THE STATE OF SOUTH CAROLINA
In The Court of Appeals

Appellate Court Case No. 2025-000624

RECORD ON APPEAL

THE CANNON BUILDING

A1 / A002 CHARLES STREET CANNON GATE ELEVATION
SCALE: 1" = 1'-0"

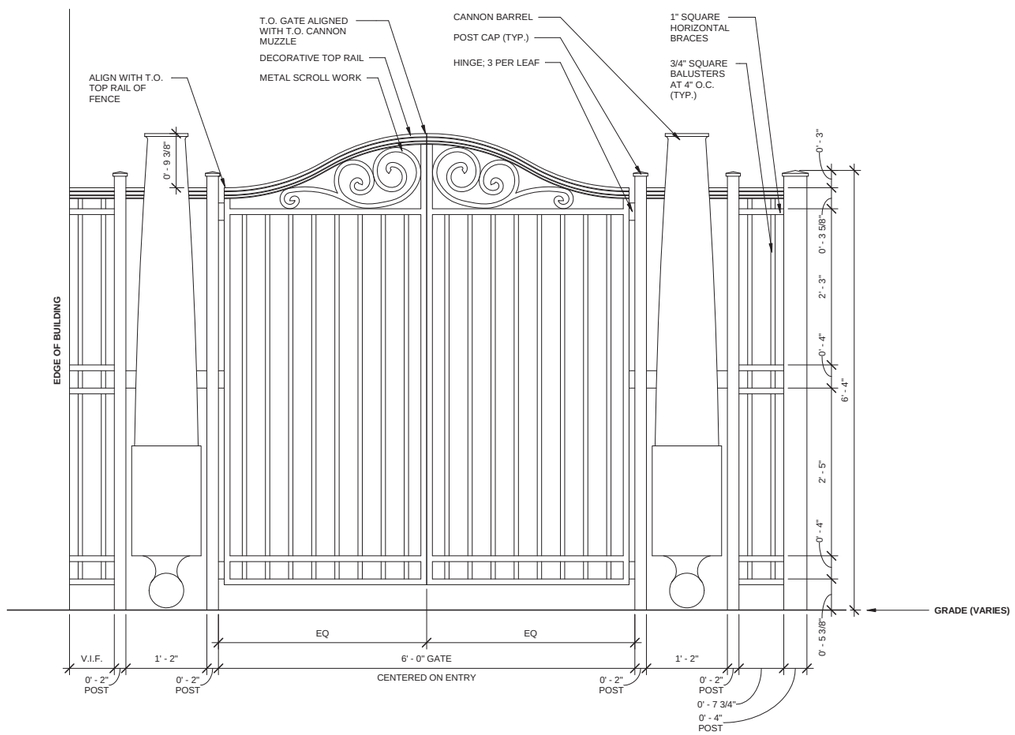
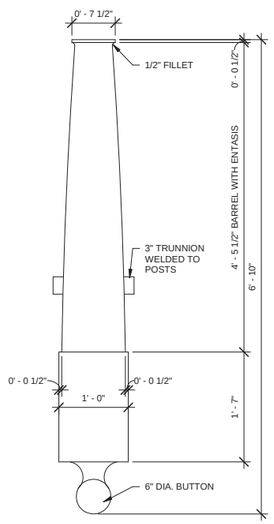
3. Staff is not in favor of the utilization of cannons within the ironwork at the entry gate on Charles Street as drawn on Sheet A002, Drawing A1 because they begin to create a false sense of history on the project site.

A1 A102 SECOND & THIRD FLOOR PLANS (CURRENT PROPOSED)
SCALE: 1/8" = 1'-0"

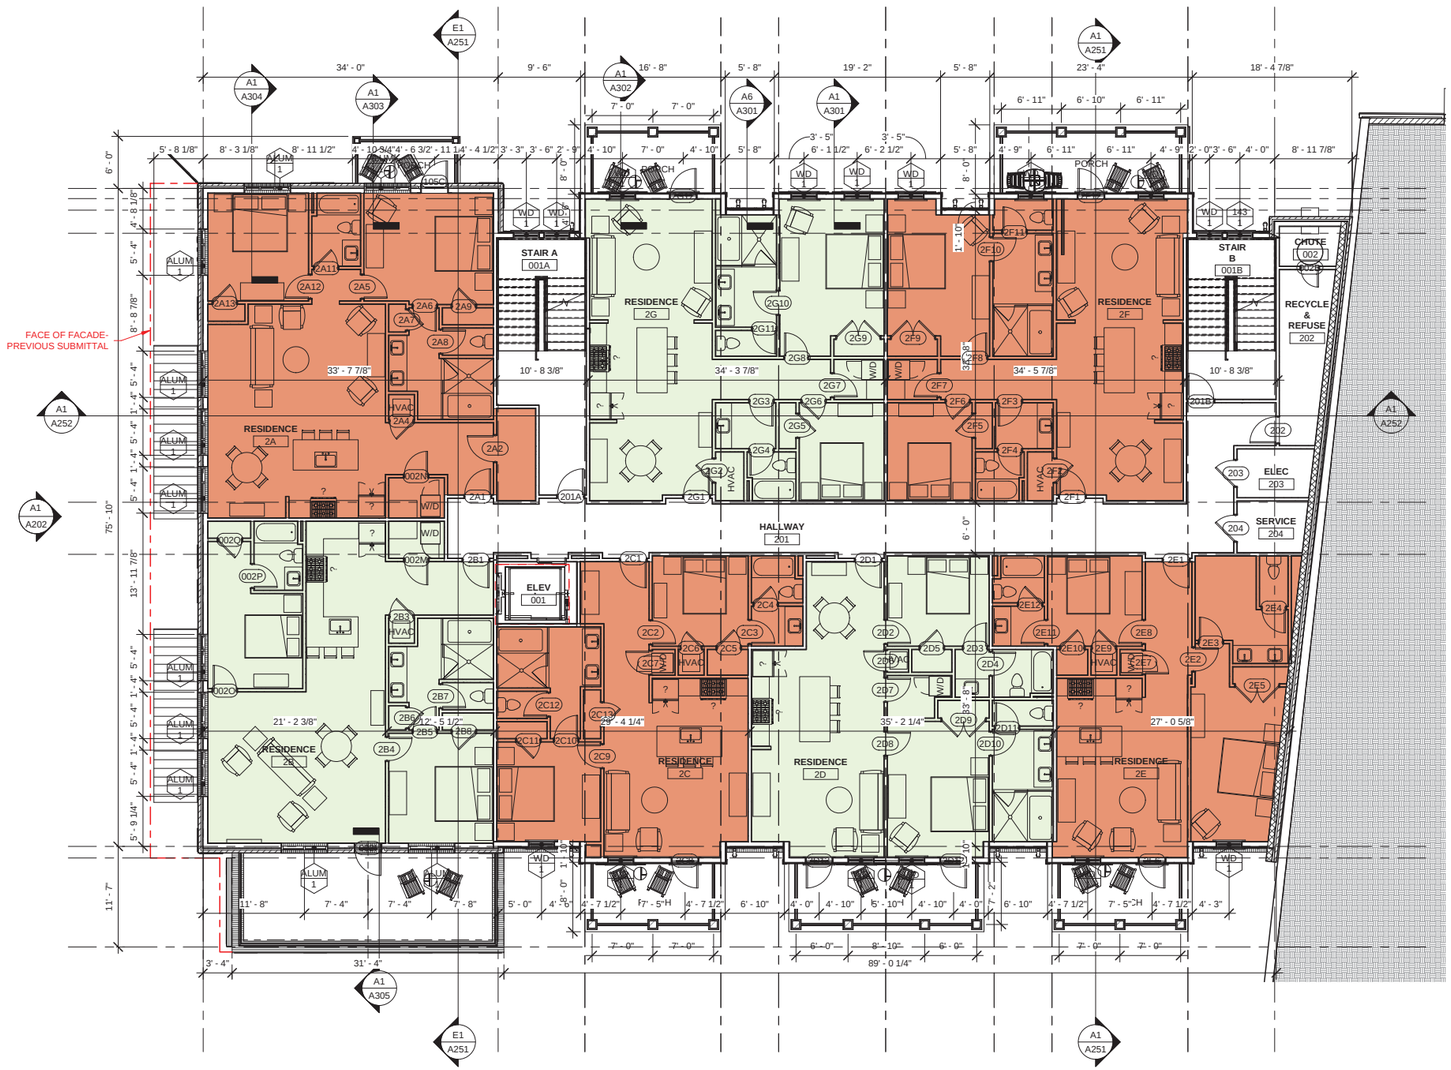
D. The parapet cap of this building has been lowered 3'-4" since the conceptual approval, and the applicant has shifted the building façade along Charles Street back from the street significantly. It appears from Sheet A102 that this reduction in building length is slightly more than 5'.

A1 / A301 WALL SECTION AT LAP SIDING OVER BRICK
SCALE: 1" = 1'-0"

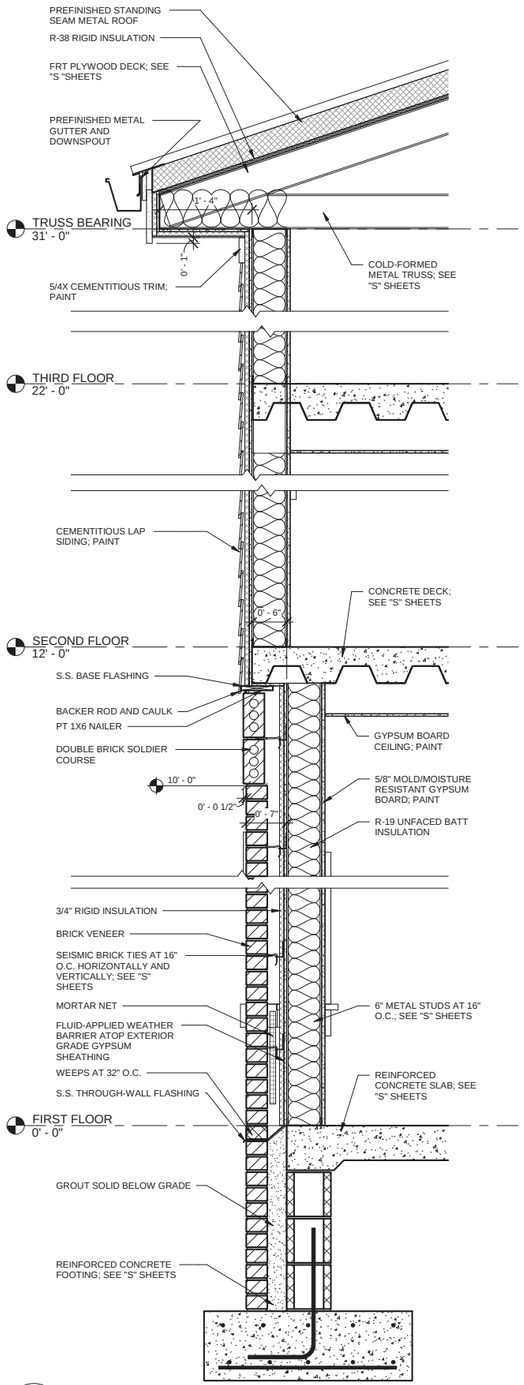
4. On Sheet A301, Drawing A1, Staff recommendation is that a skirt board is added at the termination of the lap siding where it meets the brick below.
5. Regarding Drawing A1 on Sheet A305, Wall Section Through Lobby, Applicant to clarify if any drainage elements associated with this second-floor terrace will be visible. If so, Applicant to provide a detail.

A1
A302

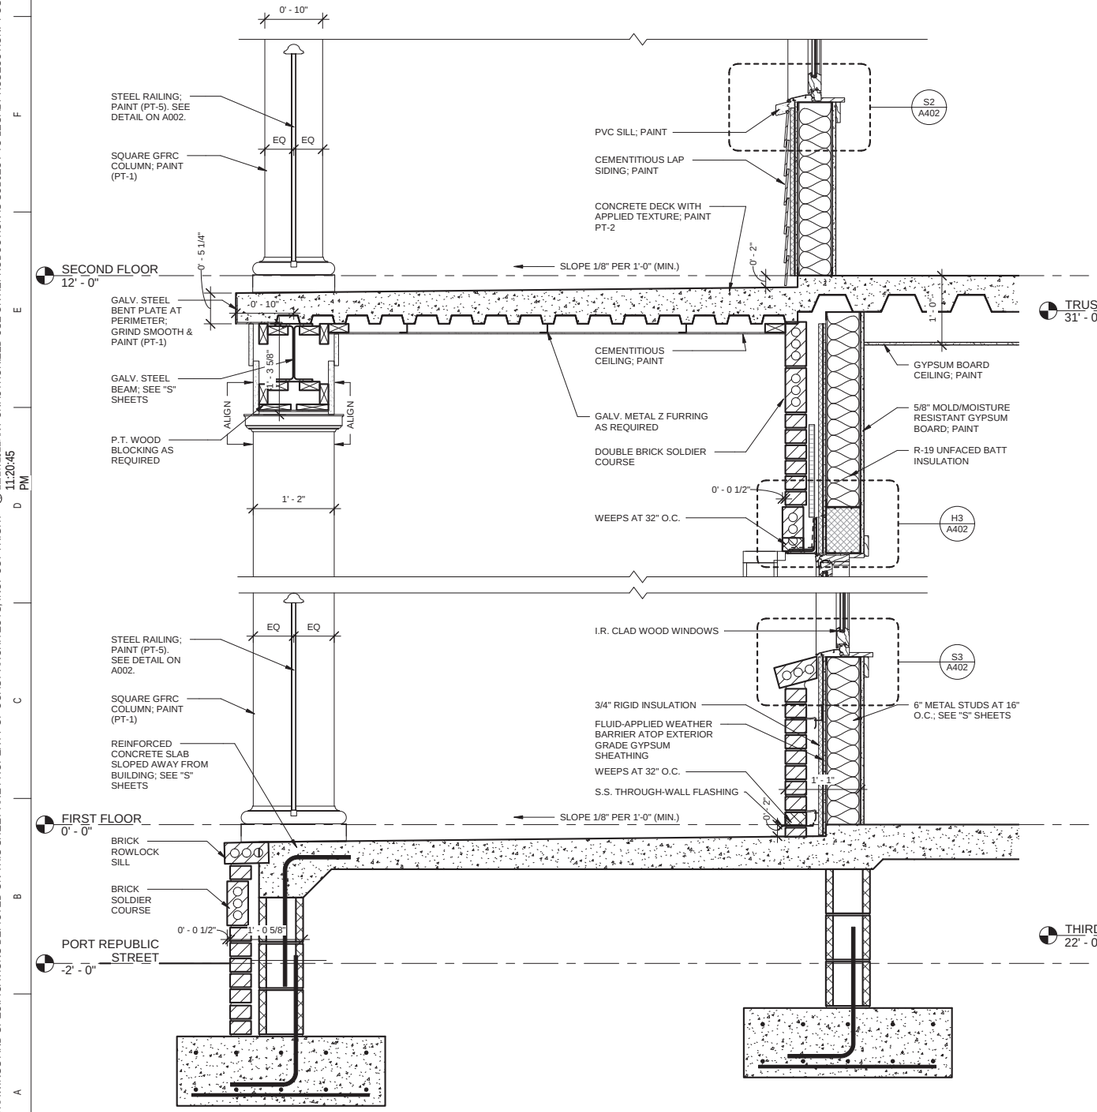
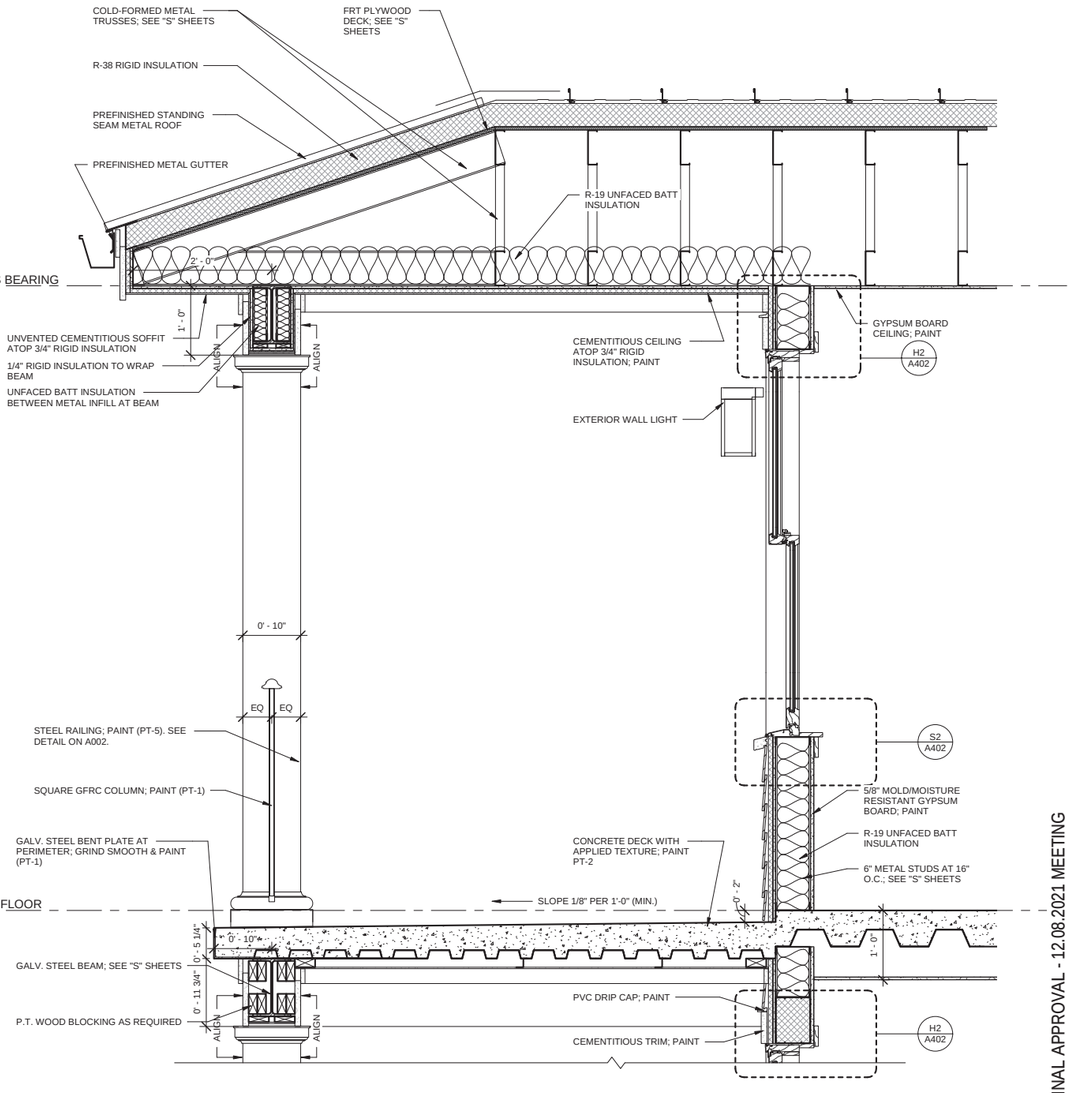
c. In drawings A1 on Sheet A302, Staff recommendation is that the outside face of the proposed column base aligns with the outside face of the foundation wall below. Staff recommends the Applicant revise design of porches to achieve this relationship.

A1 / A305 WALL SECTION THROUGH LOBBY
SCALE: 1" = 1'-0"

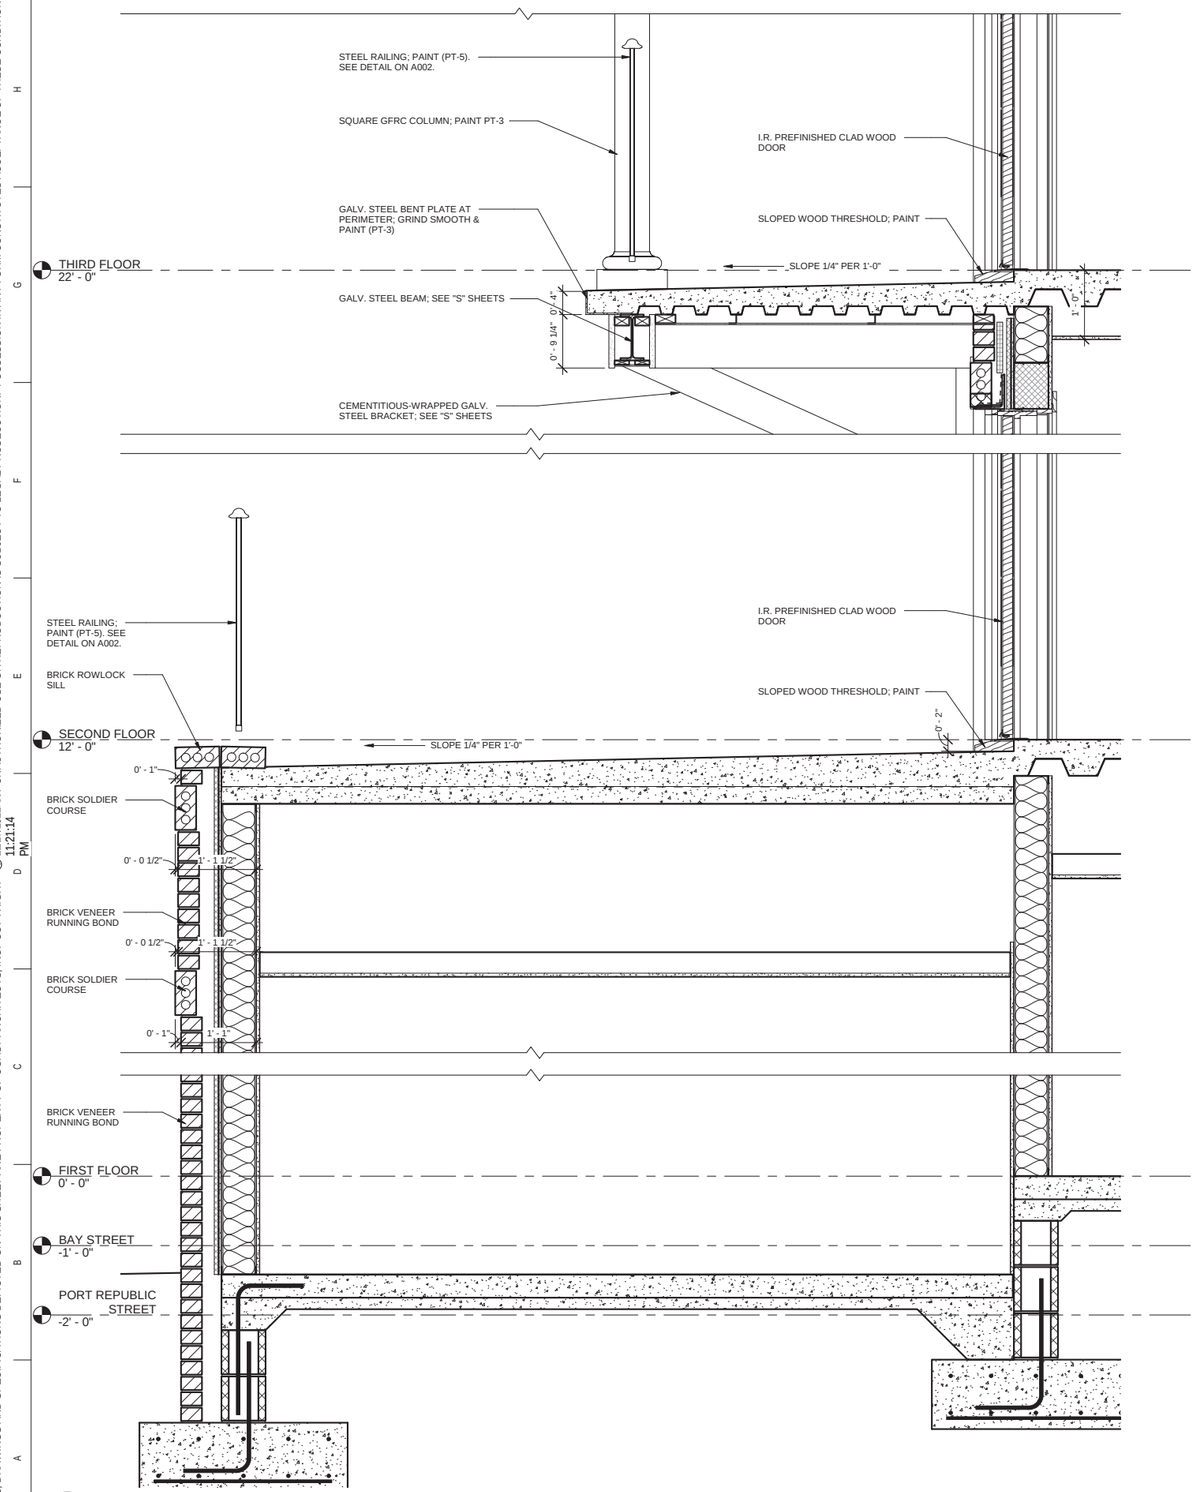
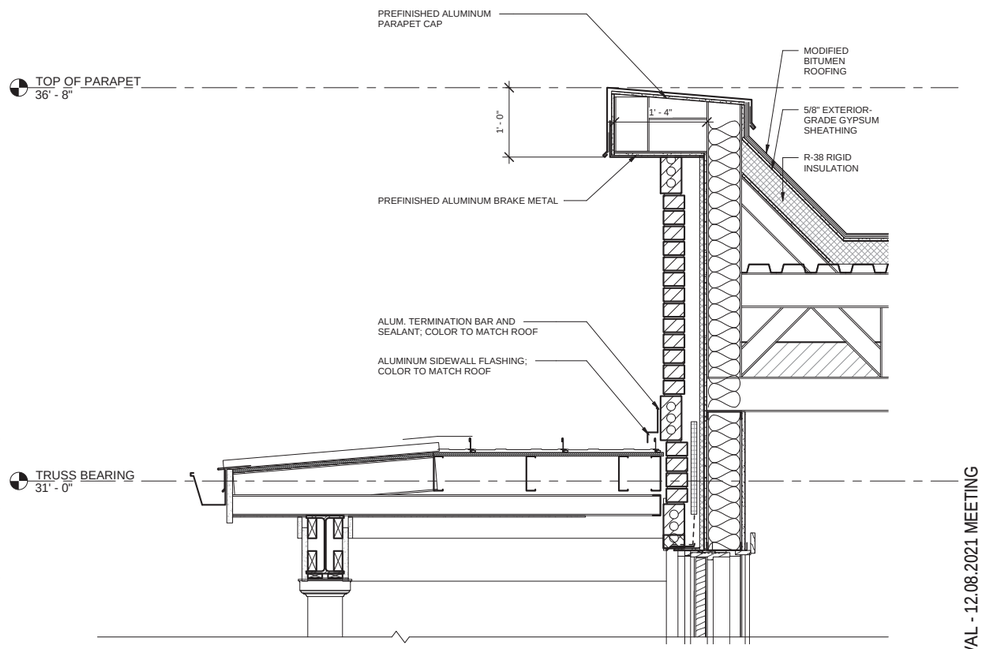
5. Regarding Drawing A1 on Sheet A305, Wall Section Through Lobby, Applicant to clarify if any drainage elements associated with this second-floor terrace will be visible. If so, Applicant to provide a detail.
